Project:	Highways England Spatial Planning Arrangement	Job No: 60600479 DM014.011
Subject:	South Caldecotte, Audit of revised forecast VISSIM model	
Prepared by:	Paula Gomez Nuñez and Alex Pina Botella	Date: 20/04/2020
Checked by:	Javier Pardo	Date: 21/04/2020
Verified by:	Phil Arnold / Liz Judson	Date: 22/04/2020
Approved by:	John Alderman	Date: 24/04/2020

Executive Summary

This Technical Note (TN10) provides a summary of the audit work conducted on the revised forecast Vissim models (dated 2nd April 2020) developed for the A5 Kelly's Kitchen Roundabout by BWB. The Vissim models have been prepared to support the planning application of an employment development at South Caldecotte in Milton Keynes.

Figure 1. Detectors added on north stream 2, signal controller 2.

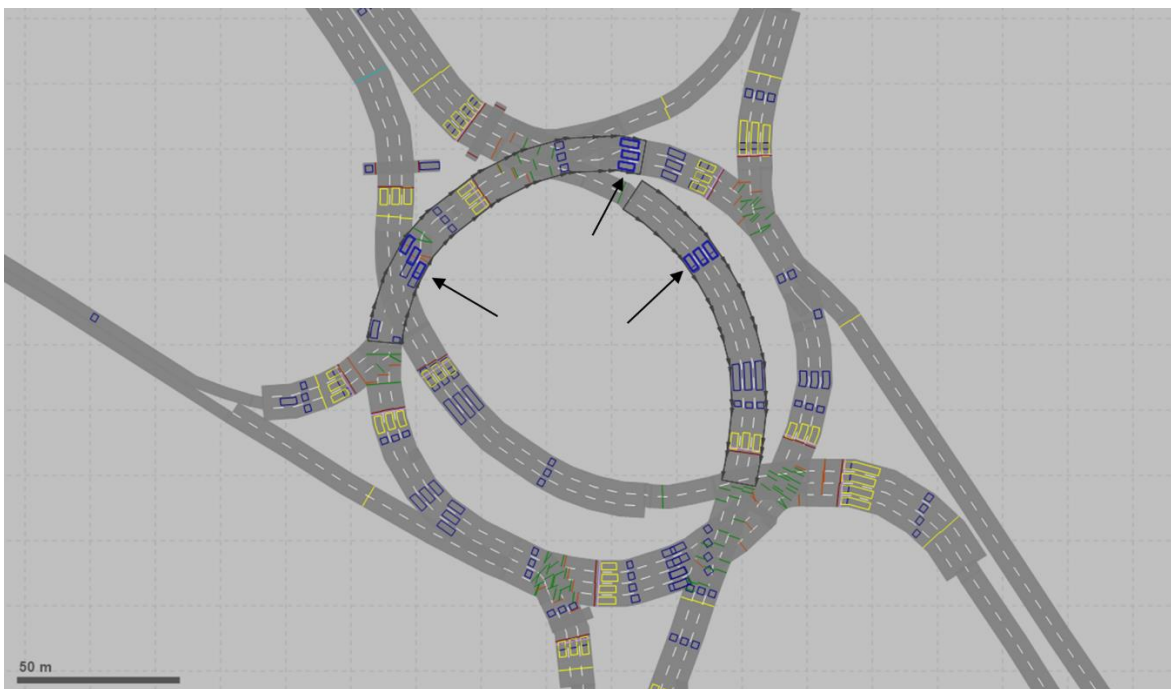
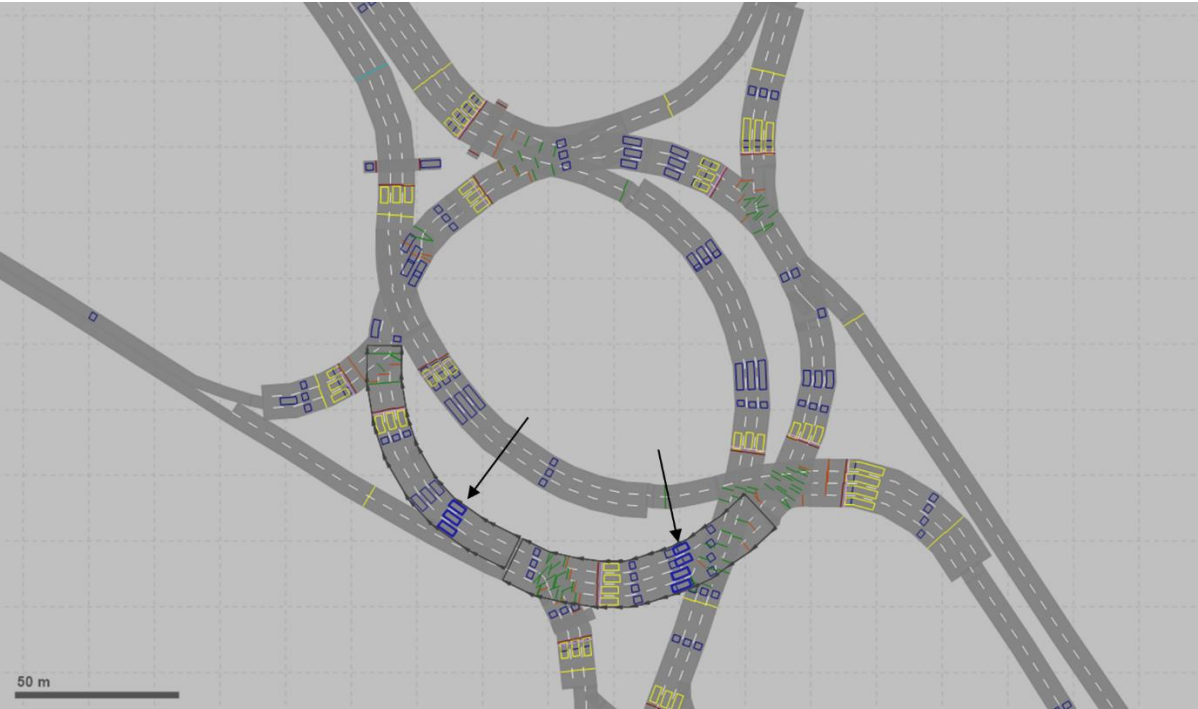
A change in the operation of signal controllers 'North Stream 2' and 'South Stream 2' has been introduced in all scenarios where additional detectors have been added into the Kelly's Kitchen Roundabout (as shown in Figure 1 and Figure 2), which limit the length of queues allowed to form inside the roundabout. These changes effectively address the queuing issues highlighted in the previous review for all scenarios and are considered appropriate.

Figure 4. Modelled AM journey times.

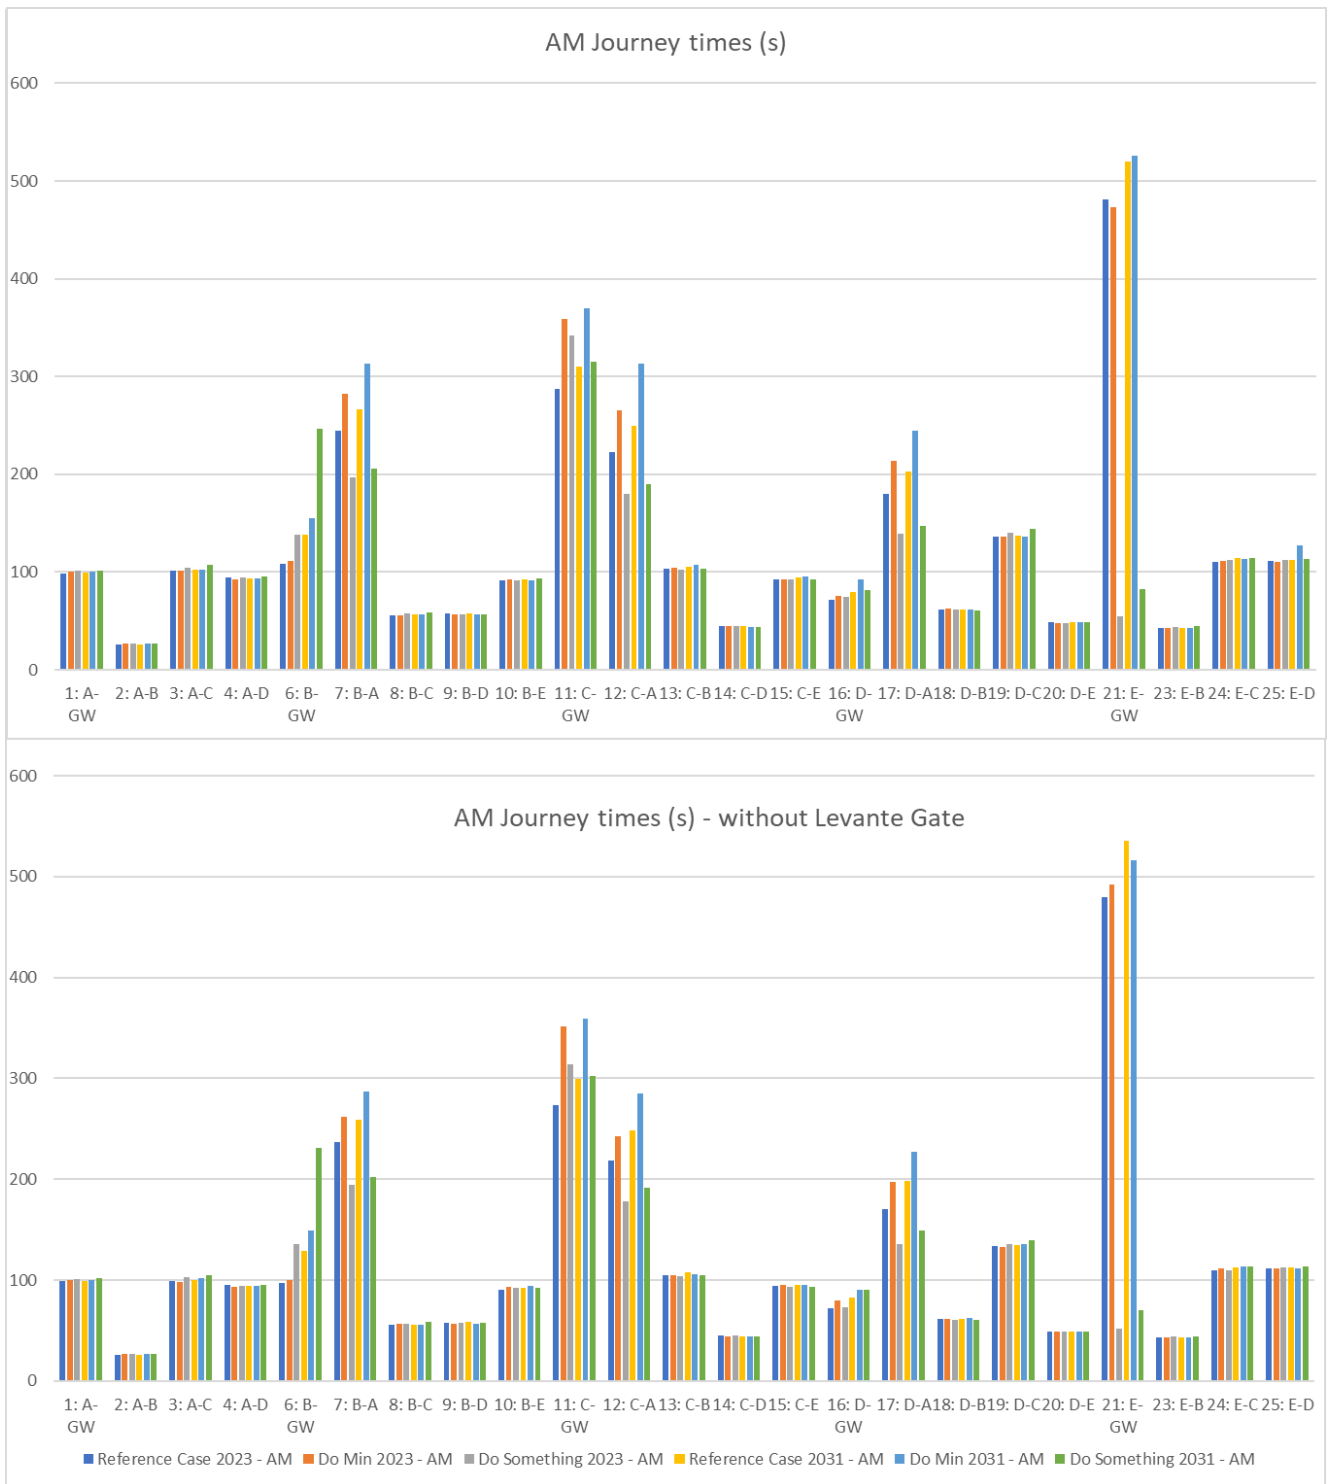
The AM journey time results are broadly consistent for both scenarios showing that:

- The mitigations in the Do Something scenario effectively offset the increase in journey times seen from the Reference Case to Do Minimum (with development trips added) on all approaches to the junction except the A5 northbound (route 6 - B-GW) and the A4146 (route 11 - C-GW), in both the 2023 AM peak and 2031 AM peak;

- The approach on the A5 northbound (B-GW) suffers a significant increase in journey time in the Do Something scenarios, The increase along this route is 30 seconds in 2023 and 107 seconds in 2031 compared to the reference case, similar results have been observed without Levante Gate flows;

- The mitigation at Tilbrook Roundabout results in a significant reduction in northbound journey times along Brickhill St (route 7 - B-A, route 12 - C-A, and route 17 - D-A); and

- The change in lane allocation at the southbound approach on the A5 (route 21 - E-GW) in the Do Something scenarios result in a large reduction in journey times, such that it is an improvement to those in the Reference Case.

Figure 5. 2023 AM Peak model observations

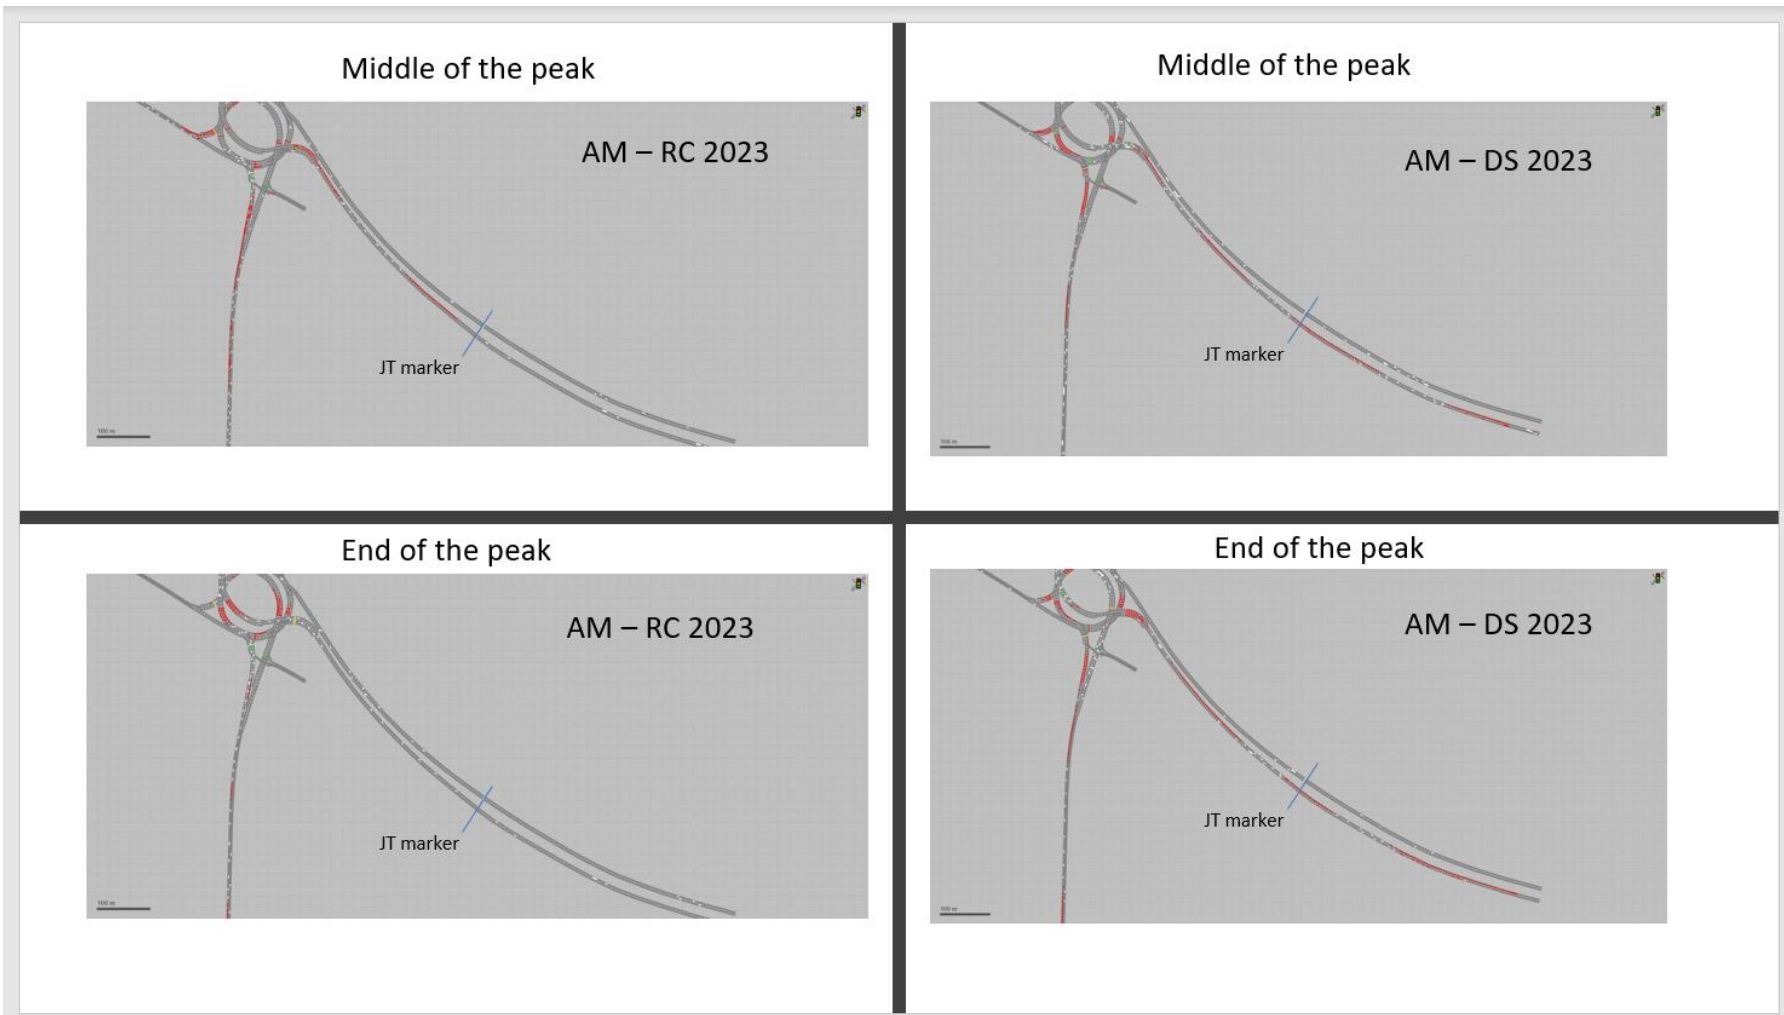
In addition to the analysis of the model outputs presented within the BWB technical note, AECOM have undertaken observation of model runs to understand the extent of the queuing generated on the A5 south approach in the 2023 AM peak Reference Case and Do Something scenario. Screenshots of these observations are presented below in Figure 5. The observations indicate that queuing increases significantly in the Do Something scenario when compared with the Reference Case scenario.

From HE's perspective AECOM recommend that further measures are sought to ensure that the impact of the proposed development on the A5 northbound approach is not considered severe. This could potentially be demonstrated through the optimisation of signal timings (this should be consistent and applied in all scenarios) that protects the operation of the A5 approaches and ensures that the impact of the South Caldecotte development on these arms is not severe.

Figure 7. Network Performance results for total delay¹ including latent delay.

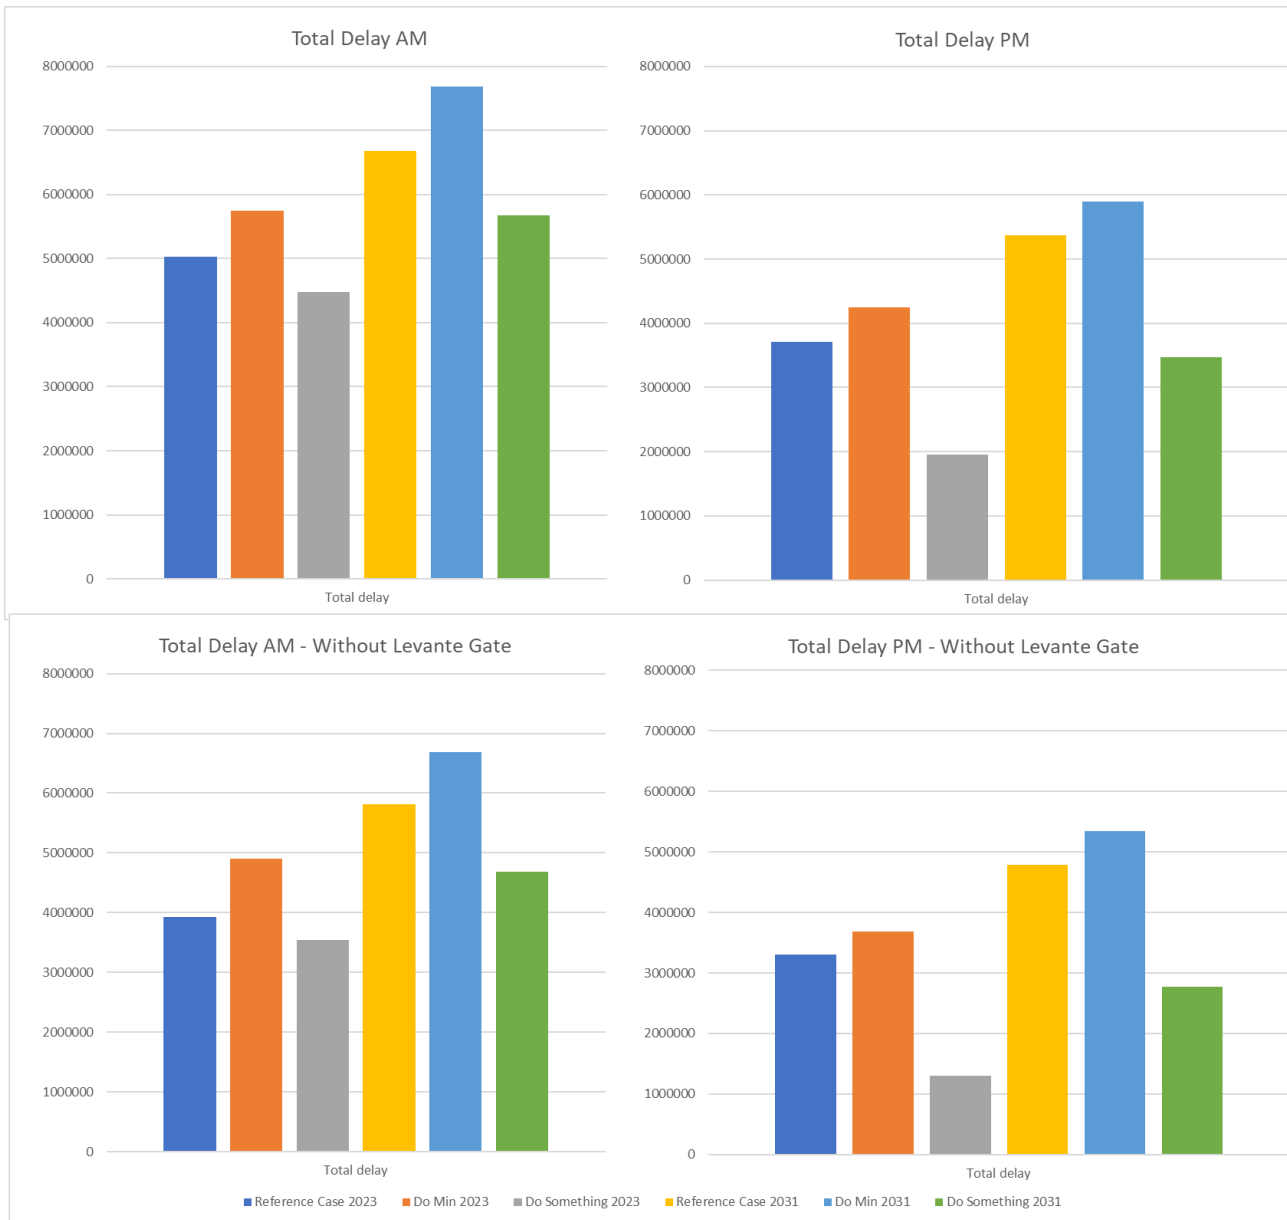
There is predicted to be a significant reduction in average delay and latent demand with the implementation of the proposed mitigations (comparison between Reference Case, Do Minimum and Do Something).

The total delay figures are calculated as the delay experienced by all vehicles loaded in the network, plus the delay experienced by vehicles that could not be loaded on to the network during the simulation. The results indicate that much of the delay caused by the development in the AM peak hour is mitigated for. The results also show that there is less delay in the Do Something scenarios compared to the Reference Case scenarios in the PM peak hour.

It should be noted however that this assessment includes the mitigation at the Tilbrook Roundabout. The latent demand indicates, that due to congestion, not all vehicles are able to enter the model network.
